SUNDRY NOTICES AND REPORTS ON WELLS

8. Well Name and No.
Carmen 3 Federal Com #15H

9. API Well No.
30-015-40539

APD

UNRECOVERED TOOLS

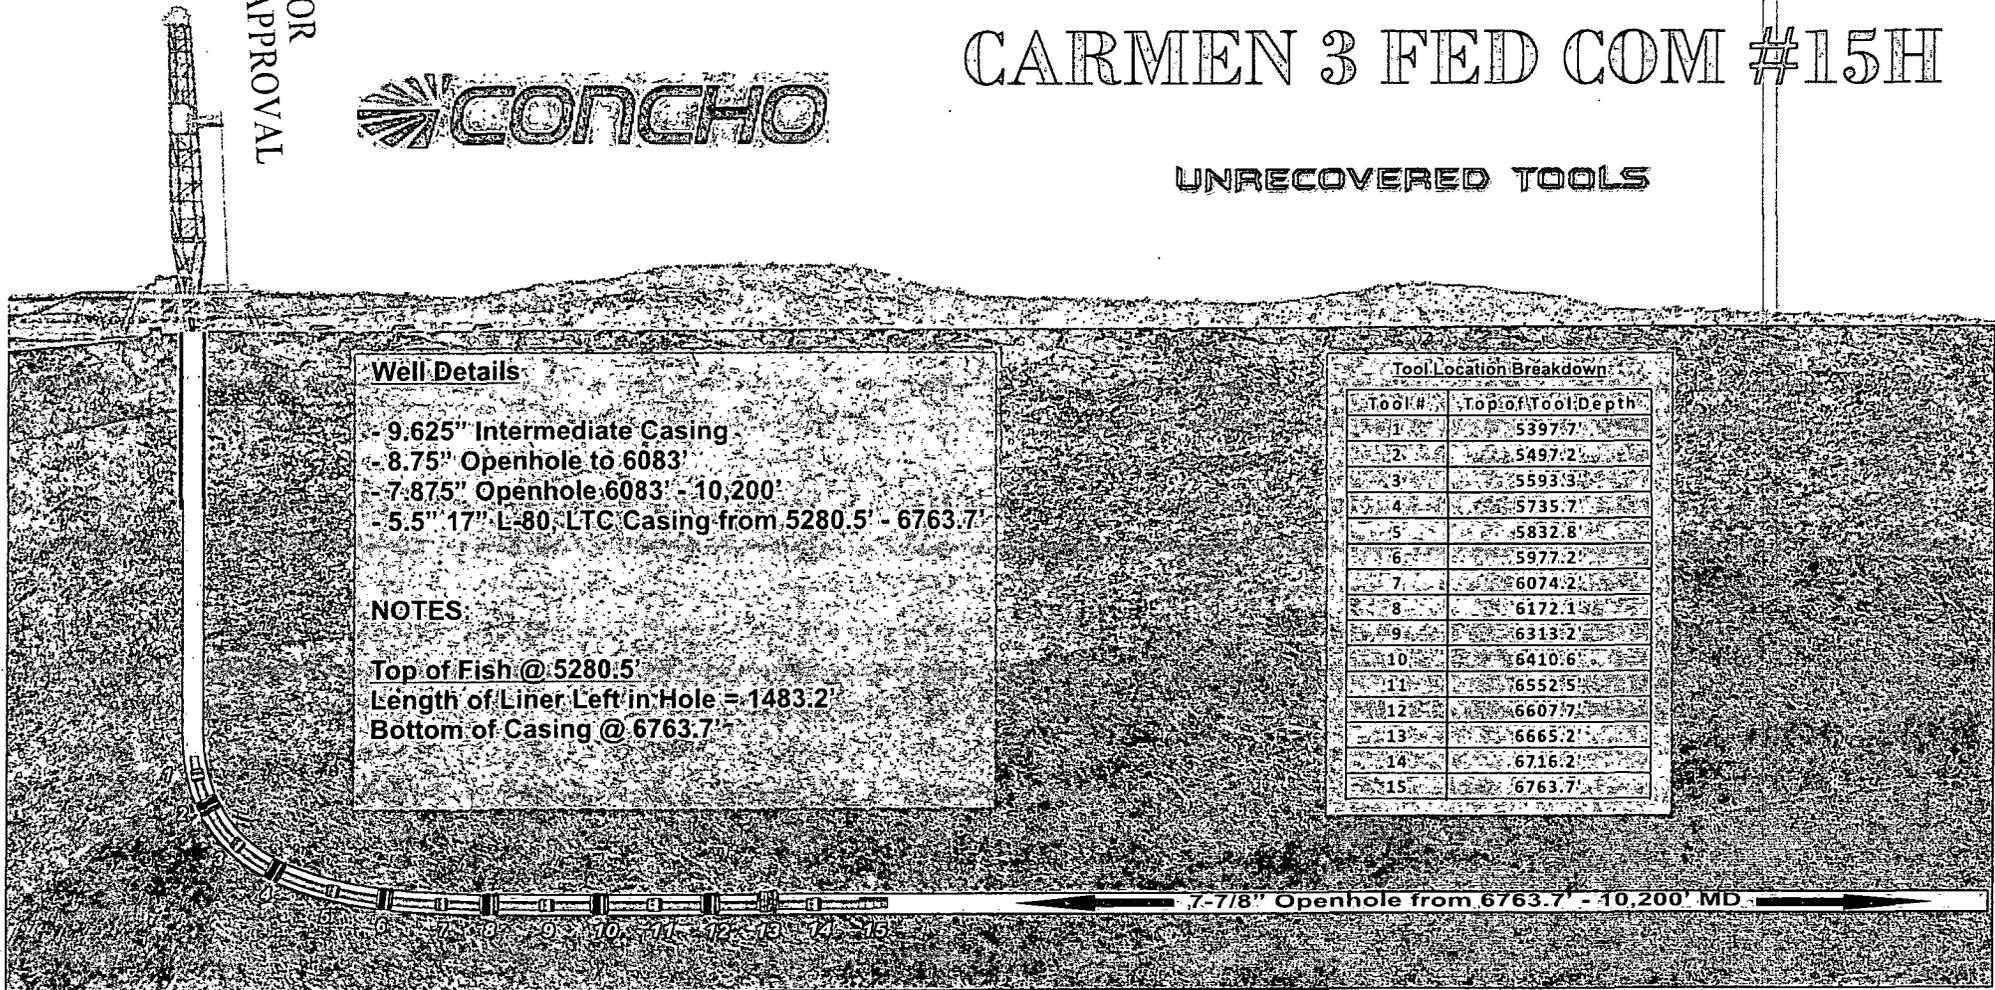
We stuck production casing and have been unable to recover all of it. The top of the casing is at 5280', and the bottom is at 6764' (see attached diagram). We propose to run 5 1/2" casing, latch the Fish, and cement through a DV at 5275' back to surface with 400sxs of Class C w/4% gel, followed by 900sxs of the 50:50:2 regular tail cement, followed by 800sxs of Class C kickoff plug cement. We would then release the drilling rig and move in a completion unit. We will drill out the DV tool and the sleeves in the 5 1/2" casing below the DV and clean out to TD at 10,200'. We would then run 4", 11.6ppf, L80 ULTFJ from TD to surface. We will then cement from TD to a DV at 5100' w/550sxs acid soluble cement. We would open the DV to leave the TOC there by circulating and then closing the DV. We will drill out the DV and then complete the well with perf/frac/plug in stages as usual. We will then remove the 4" above the DV and produce the well up the 5 1/2" casing as usual.

The 5-1/2" is 17 ppf L80 LTC.

The manufacturer of the 4" is Koppel and it was treaded by Ultra Premium Services.

The Yield of the Class C with 4%gel is 1.75 cf/sack.

The yield of the 50:50:2 is 1.34 cf/sack.

The yield of the Class C kick-off cement mixed at 16.8 ppg is 0.99 cf/sack.

The yield of the Acid Soluble Cement (which is based on Class H) is 2.54 cf/sack.

1. **If cement does not circulate to surface off DV tool set at proposed depth of 5275', the appropriate BLM office is to be notified.**
2. **Operator to notify BLM when the existing drilling rig will be removed and state how the well will be secure. -To be documented on Subsequent sundry report.**

3. **Operator to move in a completion unit within 30 days of moving off the existing drilling rig.**
4. **Operator to notify BLM a minimum of 24 hours when returning to drill/run 4" flush joint as a second spud notice**

5. **Operator to conduct BOP/BOPE/ CIT as per original COA prior to drilling out DV Tool at 5275' and the sleeves in the 5-1/2" casing below the DV tool**

6. **After running the 4" ULTFJ and cementing up to DV Tool at 5100' notify BLM if cement does not circulate off the DV tool set at 5100'.**
7. **Surface disturbance beyond the existing pad must have prior approval**
